# Difference between Y.1731 and P802.1ag

December 6, 2006

T. Hatano, K. Minami, M. Suzuki and H. Ohta (NTT)

# TTL field values in LTRs

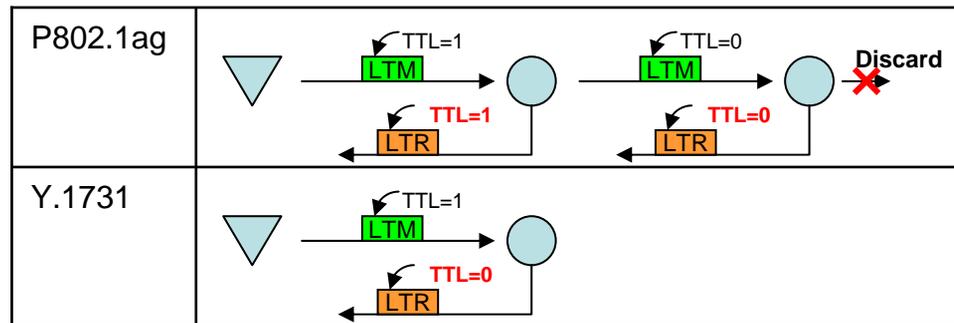
- The policies for setting TTL field values in LTRs are different between 802.1ag and Y.1731, which makes interoperability problem.
  - P802.1ag: TTL value in LTR = (TTL value in the received LTM)
  - Y.1731: TTL value in LTR = ((TTL value in received LTM) - 1)
- Proposals:
  - To ask IEEE 802.1WG to clarify the reason why the policy for setting TTL value in LTR was changed.
  - IEEE 802.1WG should make P802.1ag align with Y.1731 because
    - Y.1731 has already been approved. If the policy is changed, there will be an interoperability problem, and,
    - Adjacent information retrieval is easier by Y.1731 (When an LTM with TTL = 1 is sent in order to retrieve adjacent node information, adjacent node and next-adjacent node would reply with LTR according to P802.1ag while only the adjacent node would replies LTR according to Y.1731).

- Otherwise, IEEE 802.1WG should use different OpCode in LTM/LTR in P802.1ag to avoid interoperability problems.
